**1958 Agreement – Consideration of draft amendments
to existing Regulations submitted by GRE**

Proposal for Supplement 24 to the 01 series of amendments to Regulation No. 6 (Direction indicators)

Submitted by the Working Party on Lighting and Light Signalling*

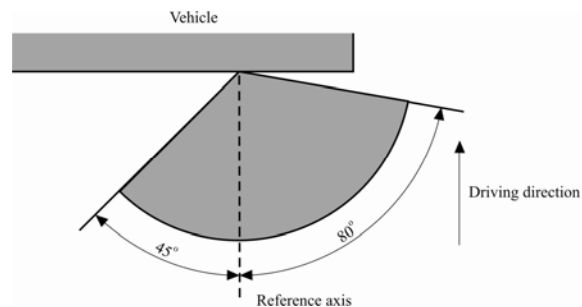
Paragraphs 6.3.3. to 6.3.3.1., amend to read:

"6.3.3. Moreover,

6.3.3.1. Throughout the fields defined in the diagrams in Annex 1, the intensity of the light emitted must be not less than 0.7 cd for devices of category 1b, not less than 0.3 cd for devices of categories 1, 1a, 2a and for those of category 2b by day; it shall not be less than 0.07 cd for devices of category 2b by night;"

Categories 5 and 6: Supplementary side direction indicators for use on a vehicle also equipped with categories 1, 1a or 1b and 2a or 2b direction indicators

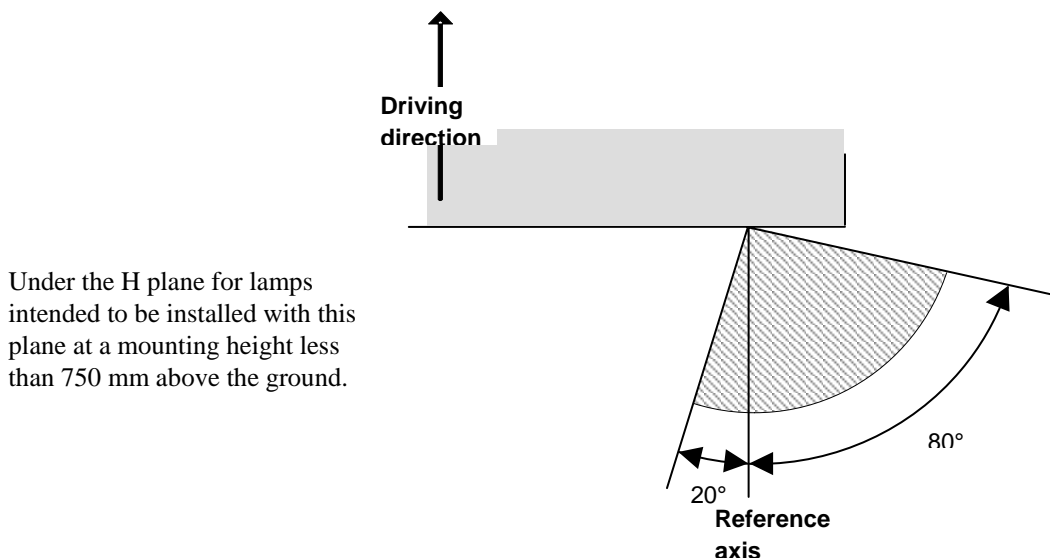
Add a new diagram and associated text, to read:

In all cases, the minimum vertical angles of light distribution in space of direction indicator lamps are 15° above and 15° below the horizontal except:

- (a) Direction indicator lamps intended to be installed with the H plane of the lamp at a mounting height of less than 750 mm above the ground, for which they are 15° above and 5° below the horizontal;
- (b) Optional direction indicator lamps intended to be installed with the H plane of the lamp at a mounting height of more than 2100 mm above the ground, for which they are 5° above and 15° below the horizontal;
- (c) Direction indicator lamps of Category 6, ...
